**METROPOLITAN GOVERNMENT OF NASHVILLE AND DAVIDSON COUNTY**

**STAFF RECOMMENDATION**  
**1906 Holly Street**  
**June 19, 2013**

**Application:** Demolition-partial; New construction-addition  
**District:** Lockeland Springs-East End Neighborhood Conservation Zoning Overlay  
**Council District:** 06  
**Map and Parcel Number:** 08314007900  
**Applicant:** Ronee Swafford and Daniel Long  
**Project Lead:** Melissa Baldock, melissa.baldock@nashville.gov

# DEMOLITION FIRST FLOOR PLAN

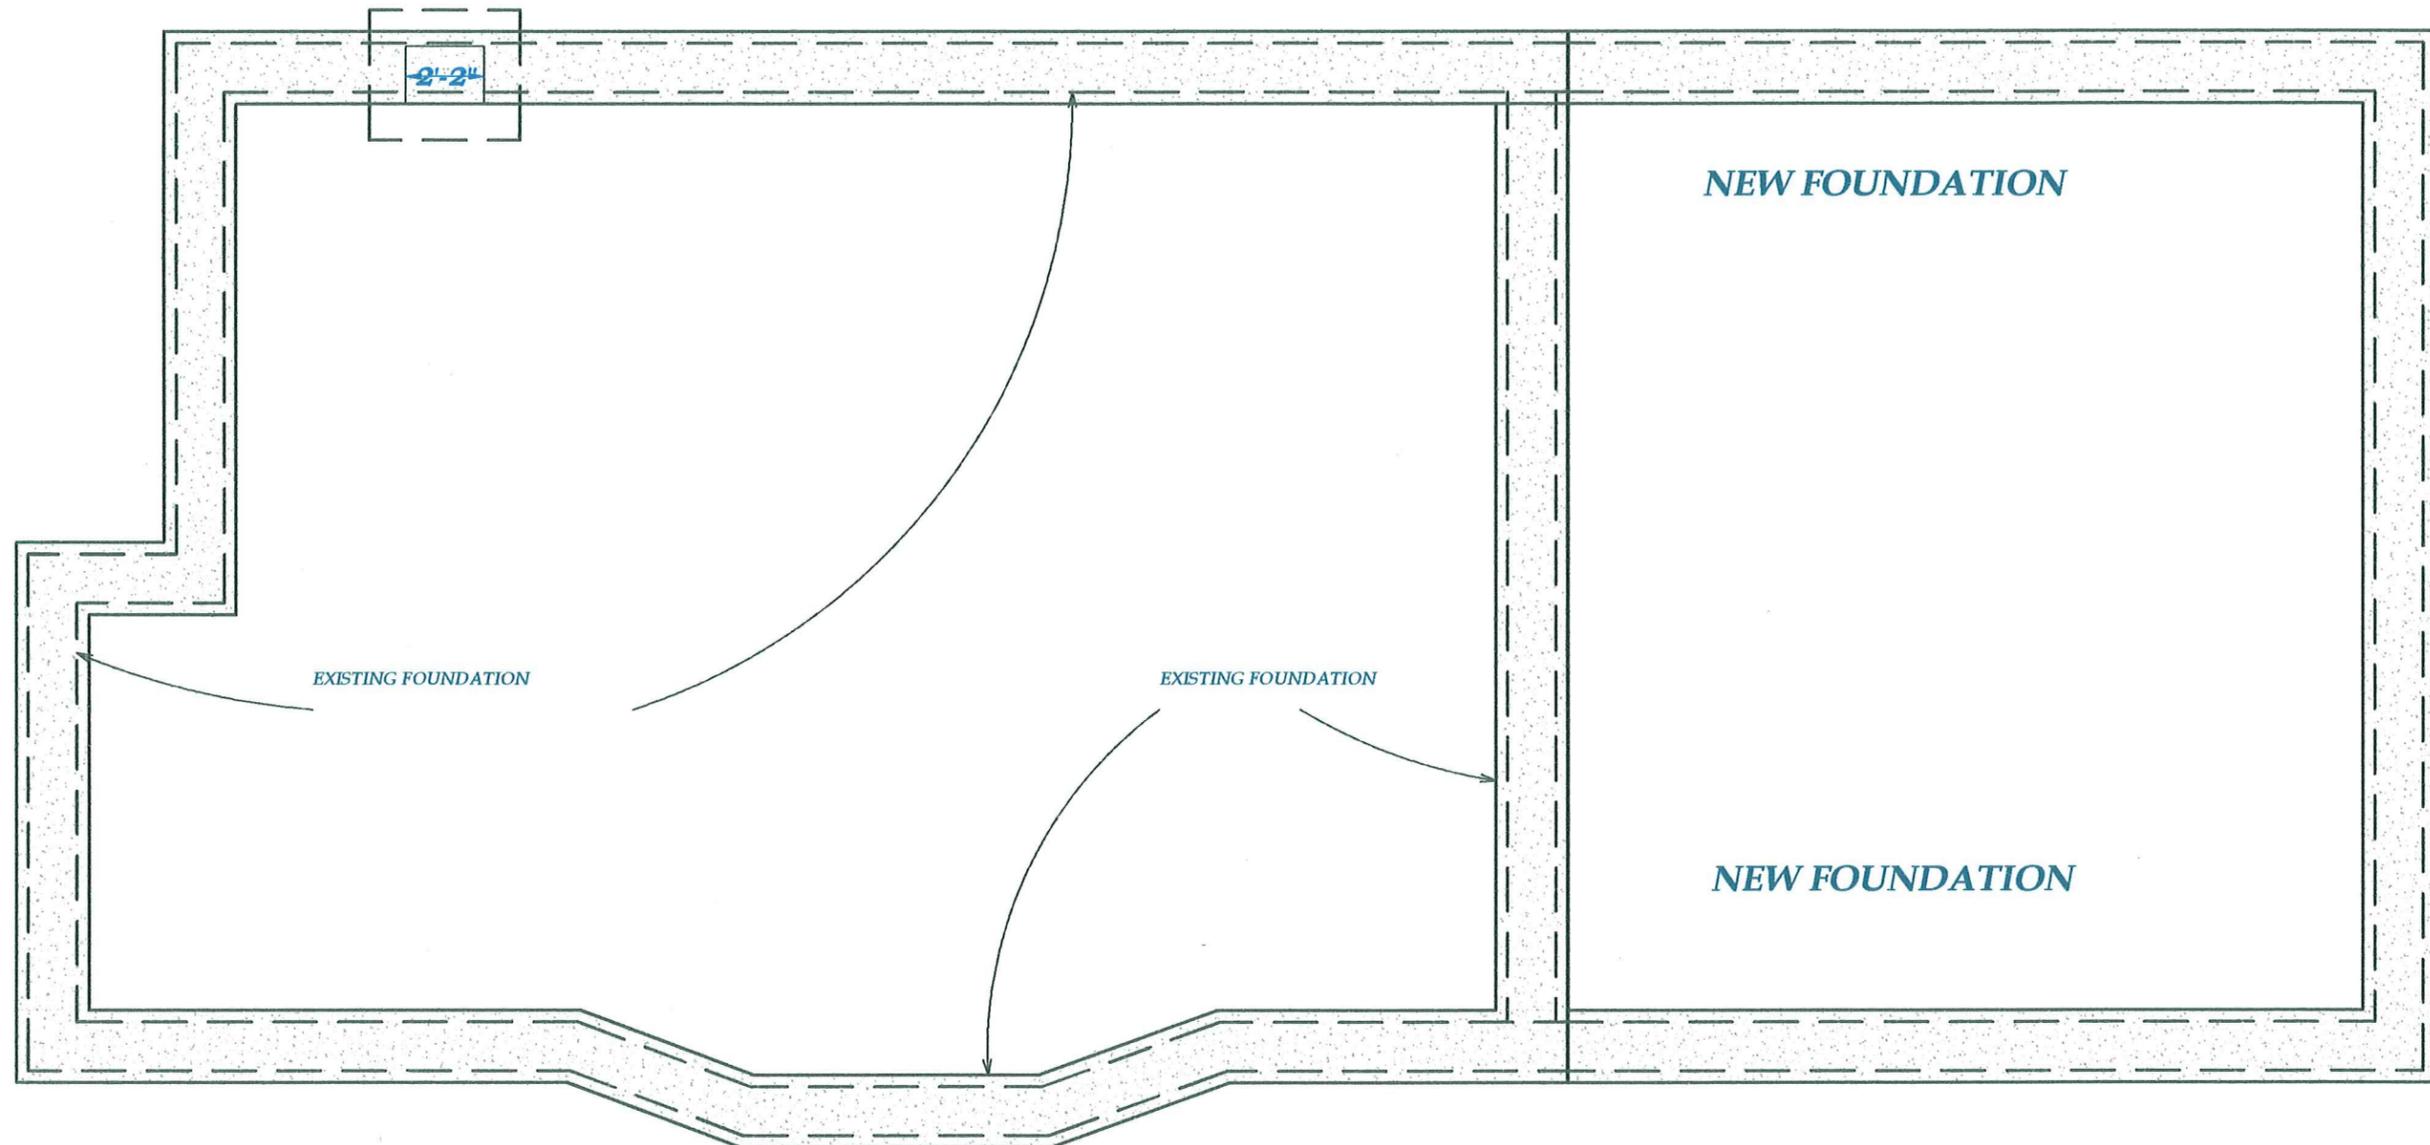
Partial Demolition: The applicant is proposing to demolish the back wall of the house, but to retain all other existing exterior walls (Figure 7). Staff finds that the removal of the rear exterior wall, which is not visible from the street, will not negatively affect the historic integrity of the house or the Lockeland Springs-East End Neighborhood Conservation Zoning Overlay. The project also requires the removal of a chimney on the front gable section of the roof (Figure 8). Staff asks that the applicant submit more information about the chimney’s current condition so that staff can assess whether or not it is appropriate to remove the chimney.

# ROOF PLAN

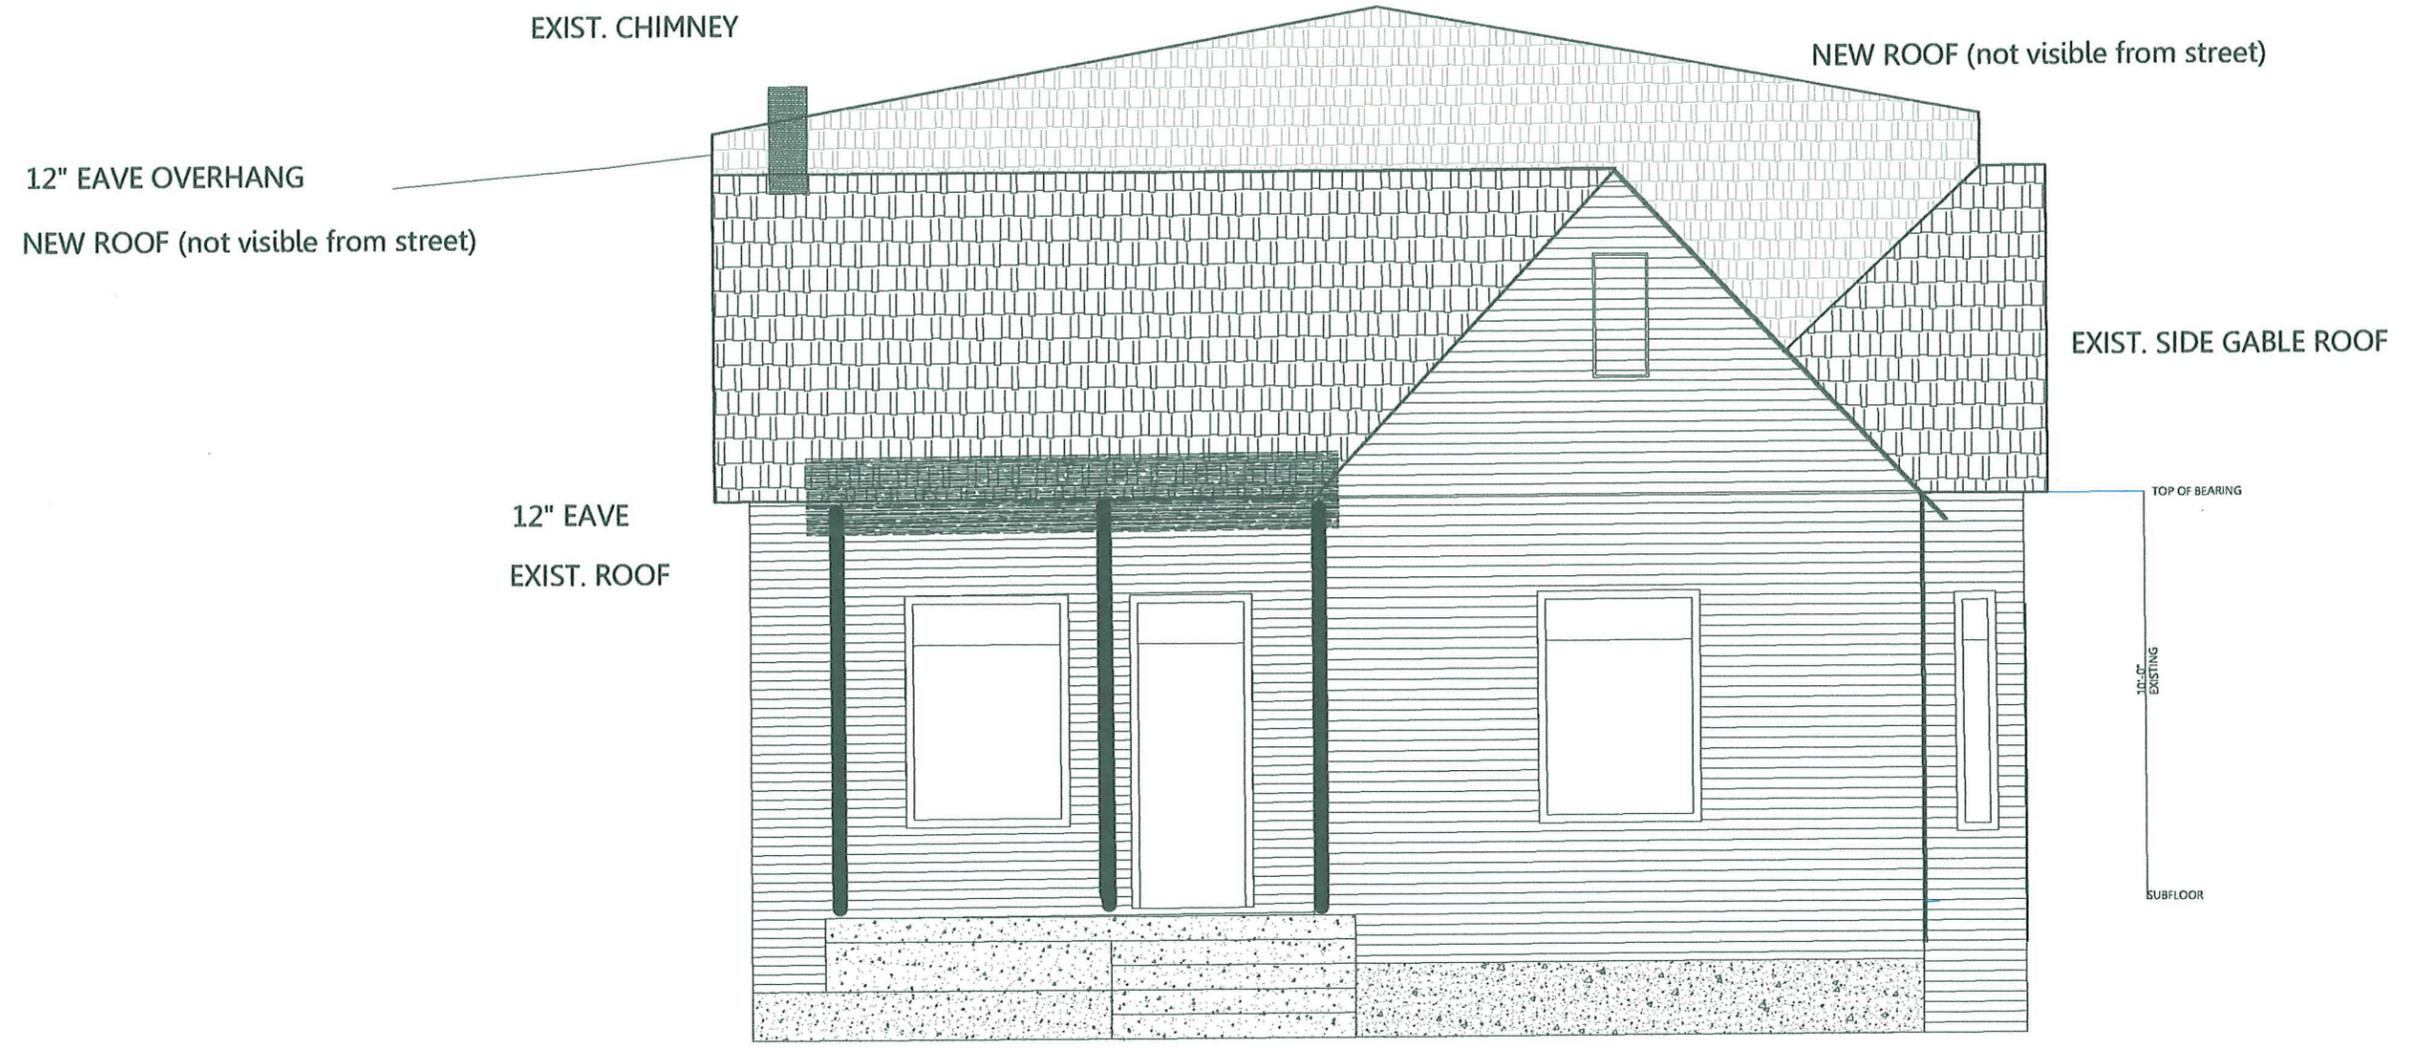
Roof: This historic house has a gabled ell form with a 12/12 slope. The proposed addition will necessitate the removal of significant portions of the original roof form, particularly on the right side of the house. The proposed addition will stack on top of several feet of the front gable and the roof of the right bay. These portions of the historic roof should be preserved, and any new structure should be constructed behind these roof forms. On the left side, because the addition will not step in the recommended two feet (2') from the back slope of the gable roof form, the historic roof form will be negatively impacted.

The addition's roof will be a three-sided hip. While hip roofs are recommended when an addition is proposed to be taller than the historic structure in order to minimize its visibility, in this instance, the location of the addition is so close to the front of the house makes the roof form inappropriate. The roof of the addition will have side slopes with a slope of 3/12. The design guidelines states that roof pitches should generally be a minimum of 6/12 in order to match the historic context.

Because the addition removes a significant portion of the historic house's roof form, and because the slope of the addition's roof is less than 6/12, staff finds that the roof form does not meet Sections II.B.5. and II.B.10. of the *Lockeland Springs-East End Neighborhood Conservation Zoning Overlay: Handbook and Design Guidelines*.

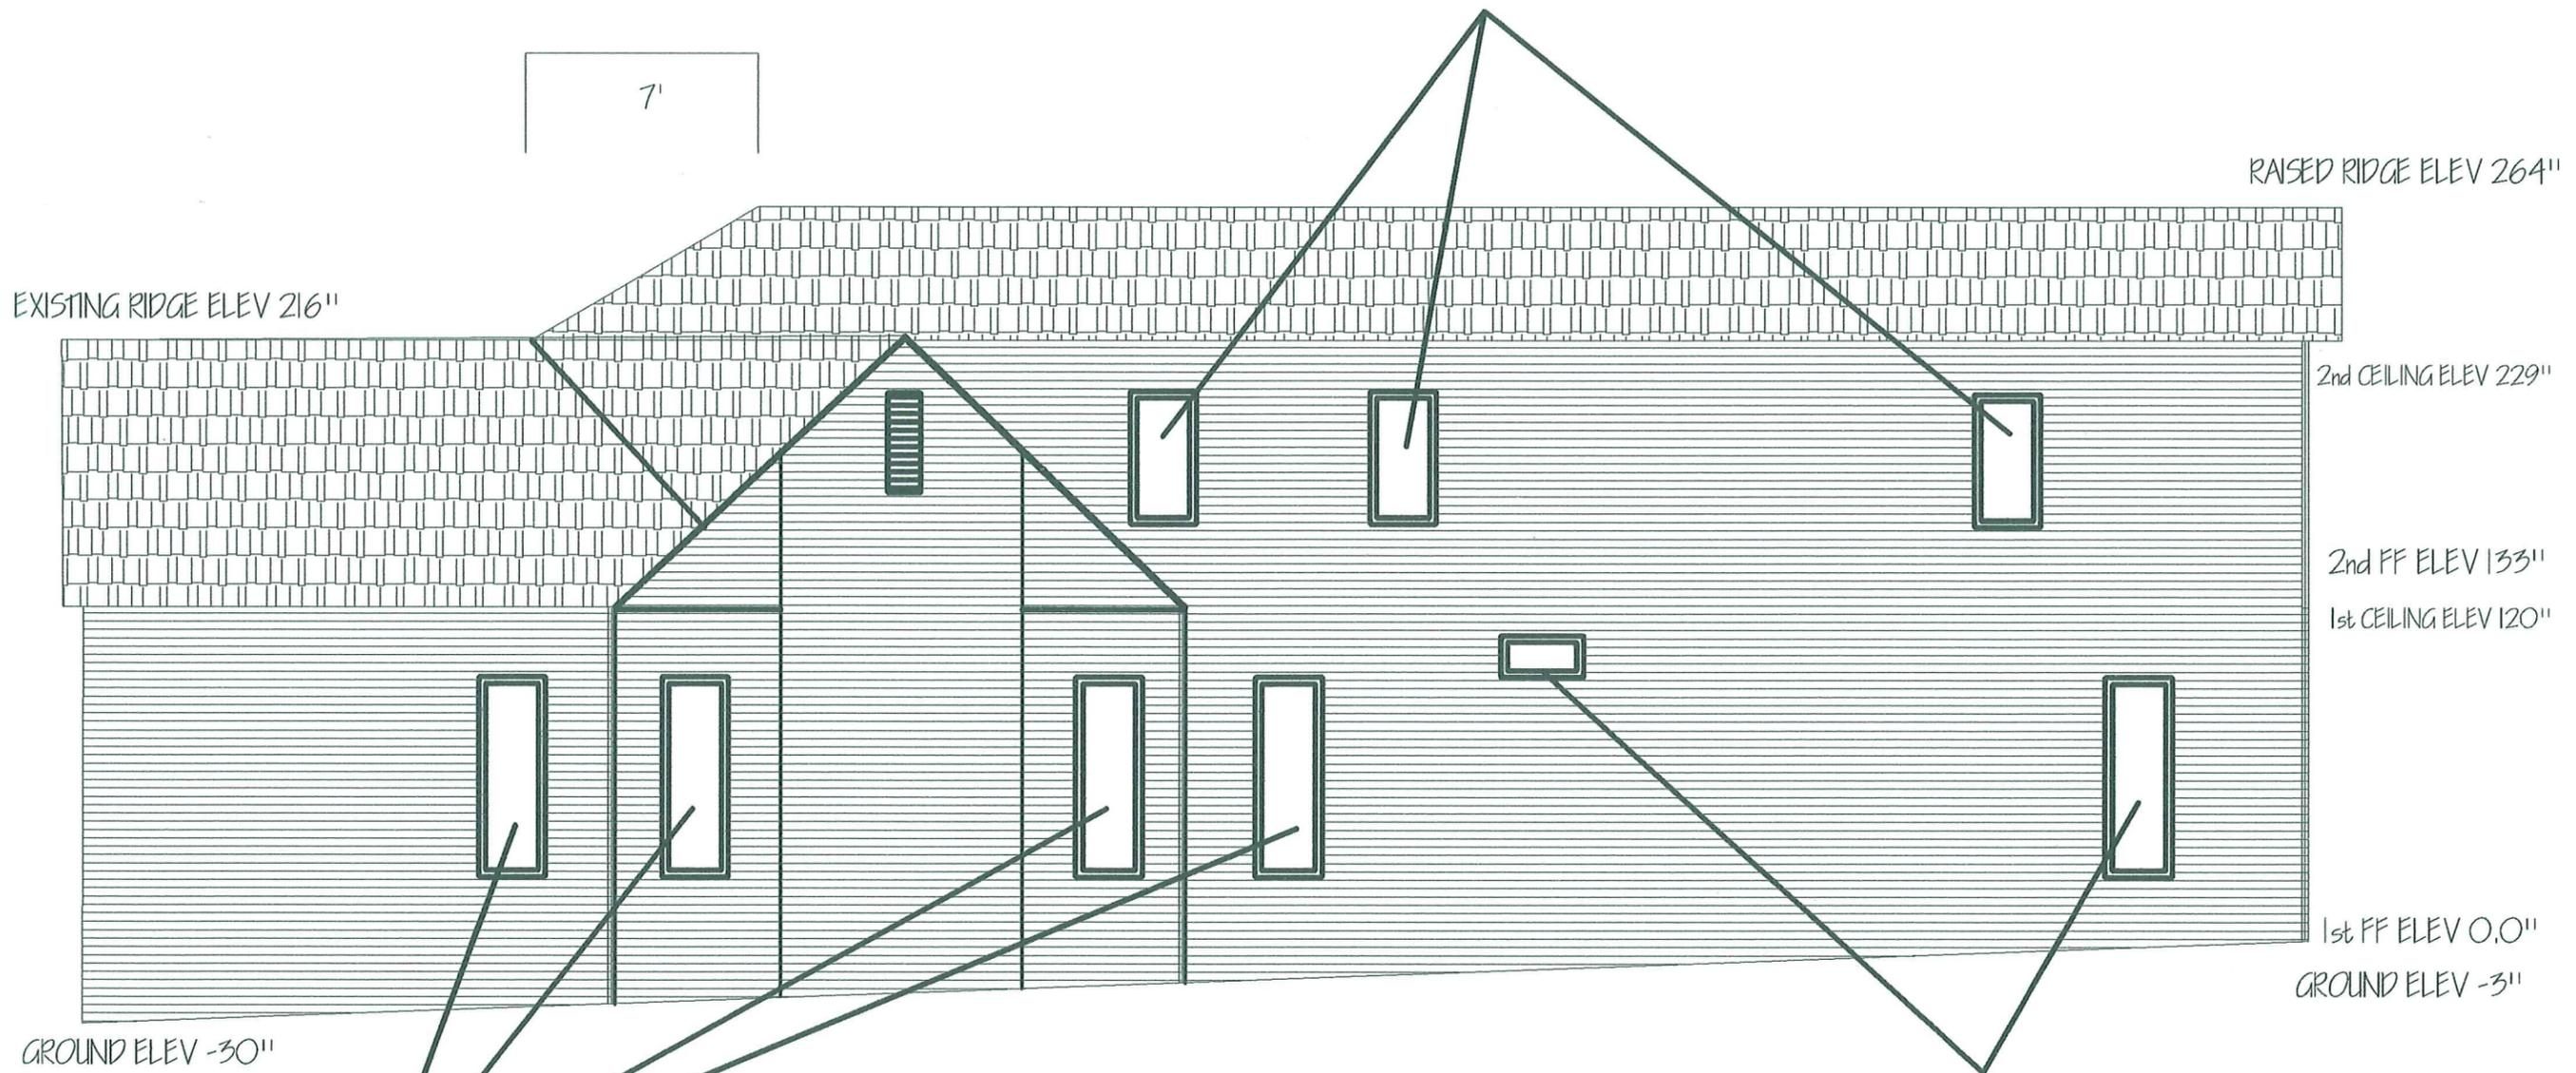
Staff finds that the addition does not meet these guidelines in several respects. The addition ties into, or just below, the ridge of the side gable portion of the roof, and continues at the height of the existing structure for approximately one foot (1'). After that point, the structure rises in height at a slope of 7/12, according to the left side elevation drawing, to be four feet (4') taller than the historic house. The four foot (4') extra height begins at a point that is approximately twenty-one feet (21') behind the front of the house. This is significantly less than the forty feet (40') that the design guidelines state should be the distance.

In addition, because the applicant is proposing to construct the addition on top of existing walls, the addition does not step in from the walls and the roof of the house as the Commission typically requires of additions. Typically, the Commission has required that two-story additions step in two feet (2') from the roof and the side walls of the house. On the left façade, the addition will stack on top of the walls and the roof of the historic side gable as well as on top of the non-historic addition behind the side gable. On the right façade, the addition will stack on top of a portion of the front gable walls and roof and will be located on top of the one-story bay feature.

Not stepping in from the roof and sidewalls of the historic house and having the two-story, four-foot (4') taller portion of the addition start just twenty-one feet (21') behind the front wall of the house will result in an addition that overwhelms the historic structure. When viewed from across Holly Street, the addition will be visually jarring and will not appear to be subordinate to the historic structure (see Figures 9-12 on next page).

The proposal will alter the original form of the house and not meet the stated objectives of the design guidelines to be “compatible in scale,” not be “visually jarring or contrasting,” and “should not disturb public facades.” Because the addition is four feet (4') taller than the historic house at a point only approximately twenty-one feet (21') behind the front wall of the house, and because it does not step in from the house's sidewalls and roofs but rather stacks on top of the house's walls, staff finds that the proposed addition does not meet Sections II.B.1., II.B.2., and II.B.10. of the *Lockeland Springs-East End Neighborhood Conservation Zoning Overlay: Handbook and Design Guidelines*.
